# UNITED STATES PATENT AND TRADEMARK OFFICE

10/802,177

Timothy W. Mehnert

<b>Office Action Summary</b>	Application No. 10/802,177	Applicant(s) MEHNERT, TIMOTHY W.	
	Examiner Ajay Vasudeva	Art Unit 3617

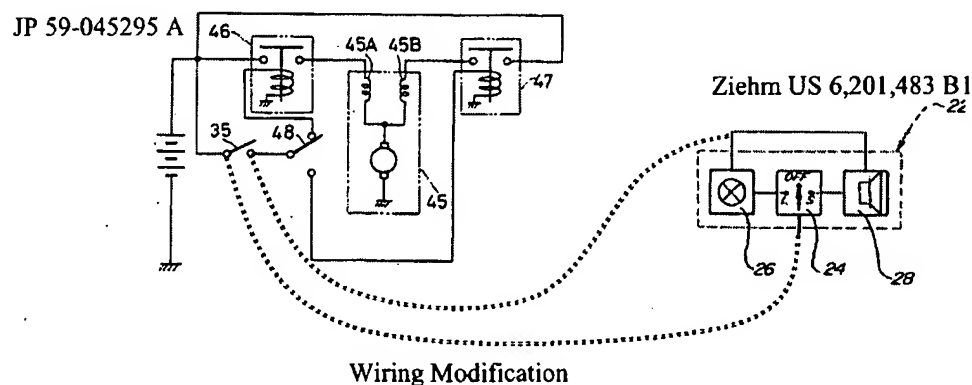
It would have been obvious for one skilled in the art at the time of the invention to connect an indicator light to the center-detecting switch of JP ('295), as taught by Ziehm. Having such indicator light would have been desirable to alert the operator of a malfunction in the tilting apparatus of the outboard motor. Such modification to JP ('295), as taught by Ziehm, would have helped a boat operator recognize that the tilting mechanism would respond only when the indicator light was illuminated. However, if the tilting mechanism failed to respond even when the indicator light was illuminated, it would clearly indicate a malfunctioning of the tilting mechanism.

As an additional advantage, such indicator light would have also provided a navigational assist mechanism for guiding the watercraft in a straight direction even in poor visibility conditions such as fog or darkness, which would have further improved the operational safety of the craft (*see below for a simplified illustration of one possible modification of JP '295, as modified by Ziehm*).

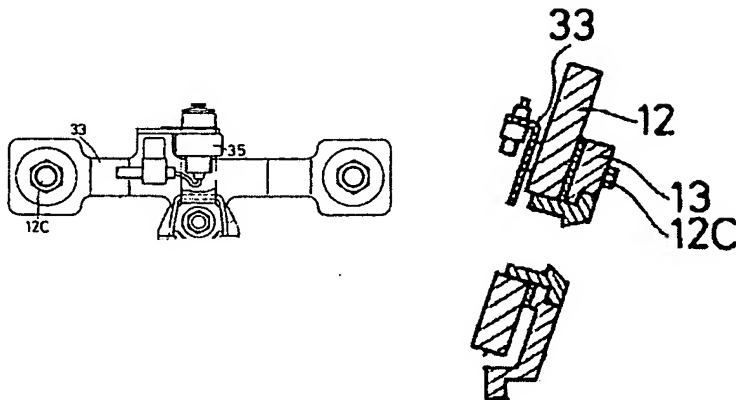
Re claim 2, the cam is coupled to the steering linkage bar via a clamp [43]. The phrase "clamp hose" has been broadly interpreted to mean a clamp that is capable of attaching over a tubular, or a hose shaped, structure. The clamp of JP ('295) meets such criterion, and is therefore considered to be a clamp hose.

Re claim 3, the switch is coupled to a fixed portion [12] of the watercraft by at least one bracket [33].

Re claim 4, small switches that are operative as "push button" or "snap-action" switches are commonly known as microswitches. The switch of JP ('295) meets such criteria, and is therefore considered to be a microswitch.

Re claim 6, the apparatus comprises a plurality of brackets [33,13], wherein a second bracket [13] and nut-bolt fasteners [12C] are employed to secure the first bracket [33] to the fixed portion of the watercraft. The switch – which itself is mounted on the first bracket – is therefore considered to be secured to the fixed portion of the watercraft by the first and second brackets. *(see simplified illustration below, as modified from figures 1 and 2).*

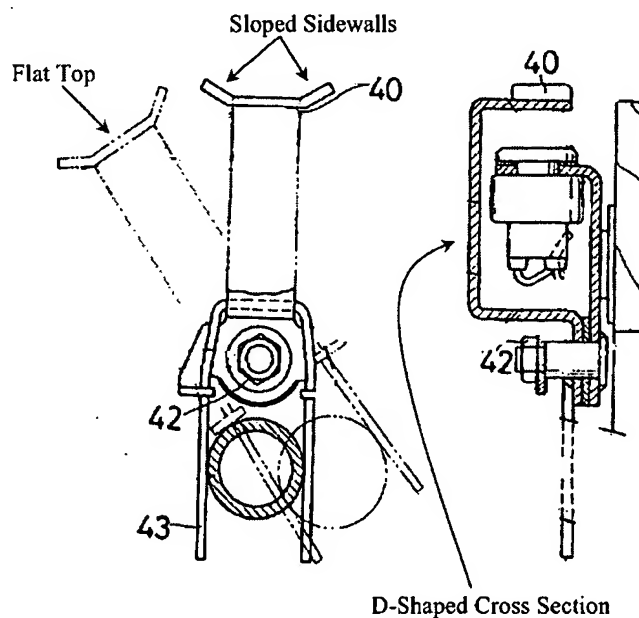
Re claims 7, 10 and 11, the cam includes two sloped sidewalls, joined by a flat top portion. The cam has a substantially D-shaped cross-section. (*see simplified illustration below, as modified from figures 2 and 3*)
